Project	<b>IEEE 802.16 Broadband Wireless Access Working Group</b> < <a href="http://ieee802.org/16">http://ieee802.org/16</a> >	
Title	<b>Piggyback Bandwidth Request Handling in Distributed Scheduling</b>	
Date Submitted	<b>2007-04-25</b>	
Source(s)	Masato Okuda and Yuefeng Zhou Fujitsu	okuda@jp.fujitsu.com Yuefeng.Zhou@uk.fujitsu.com
Re:	IEEE802.16j-07/013: "Call for Technical Comments Regarding IEEE Project 802.16j"	
Abstract	This contribution proposes a distributed bandwidth request and allocation mechanism.	
Purpose	To propose text to describe a distributed bandwidth request and allocation mechanism	
Notice	This document has been prepared to assist IEEE 802.16. It is offered as a basis for discussion and is not binding on the contributing individual(s) or organization(s). The material in this document is subject to change in form and content after further study. The contributor(s) reserve(s) the right to add, amend or withdraw material contained herein.

# Piggyback Bandwidth Request Handling in Distributed Scheduling

Figure 1 Forwarding PB-BR from MR-BS to RS

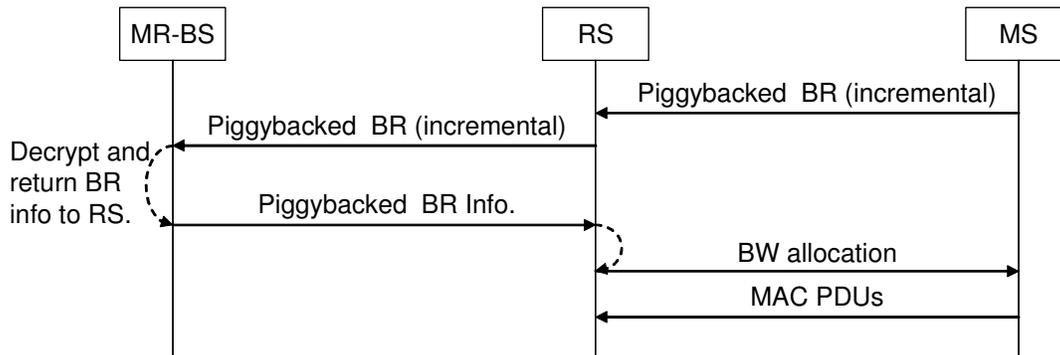
As for encrypted bandwidth request, the MR-BS decrypts MAC-PDUs and forwards piggybacked bandwidth request information to the access RS since RS cannot decrypt MAC-PDUs. See Figure 1.

Figure 2 Aggregate BR Header Superseding incremental PB-BR

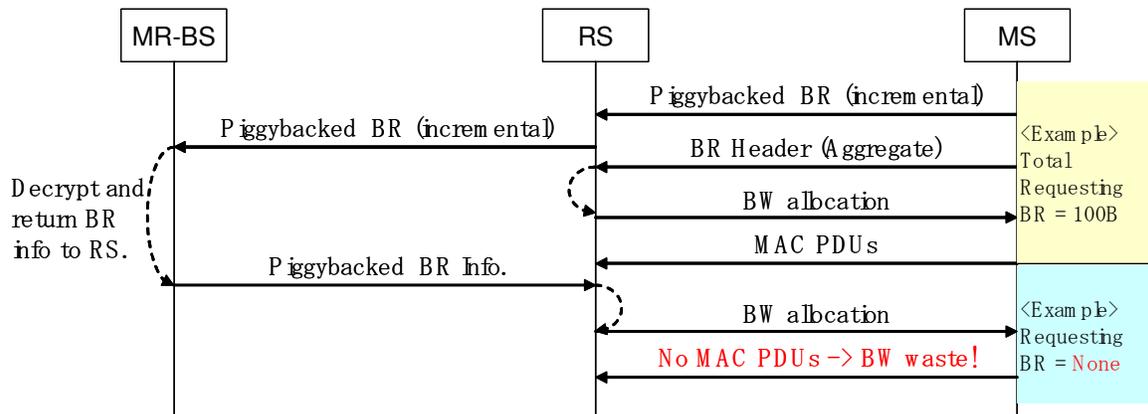
According to the current standard, MS must send BR header (Aggregate) periodically. Therefore, based on the Aggregate BR header, the RS may allocated all bandwidth requested by the MS before receiving PB-BR information from the MR-BS. In this case, bandwidth allocation based on the returned PB-BR information could be wasted. See Figure 2.

To prevent the above problem, Piggybacked BR Info sent by MR-BS shall contain packet number of MAC-PDU to which the Piggybacked BR request is attached. A MAC-PDU encrypted with AES-CCM shall contain unencrypted packet number. The access RS can use this value to manage ordering of bandwidth requests received from MS directly and via MR-BS.
